Technical Bulletin

Bulletin Number: 489 Revision Number: R-01

SUBJECT: VENDOR DEFENDOR EXTENSION

491,010,65x.x3

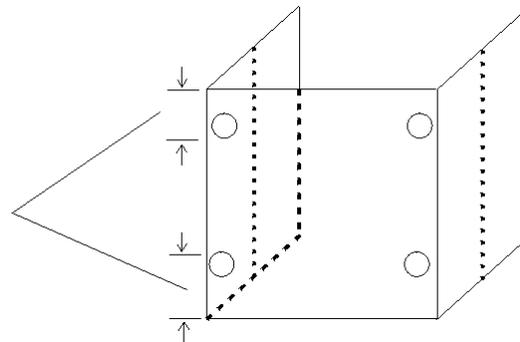
REASON: To provide an extension to the Vendor Defendor to reduce the distance between the Vendor Defendor and the top of the coin mech separator.

Note the length difference from the hole to the bottom for adjustment purposes.

ORDER: 491,010,65x.x3 Vender Defendor Extension

Figure 1

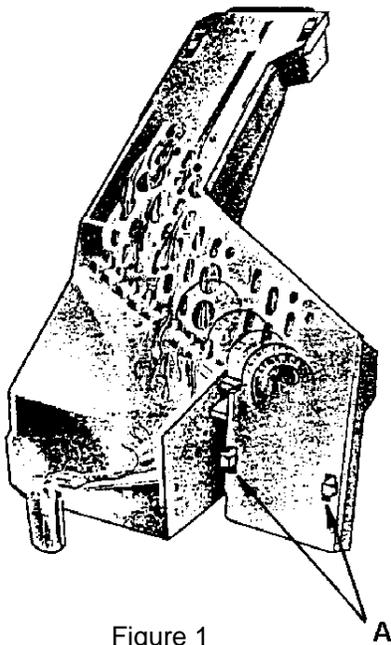
1. Locate the bottom two snaps (see "A" on figure 1) on the Vendor Defender.
2. Determine the distance between the bottom edge of the Vendor Defender chute and the coin mech funnel. Place the chute extension in position so the chute is extended the proper length.
3. Place the extension on the Vendor Defender so the top two holes ("B", Figure 2) fit over the bottom two snaps located in step 1.
4. Carefully bend the extension at the holes provided until it is secured to the Vendor Defender. See Figure 3.
5. Pass coins through the coin chute to ensure proper operation.
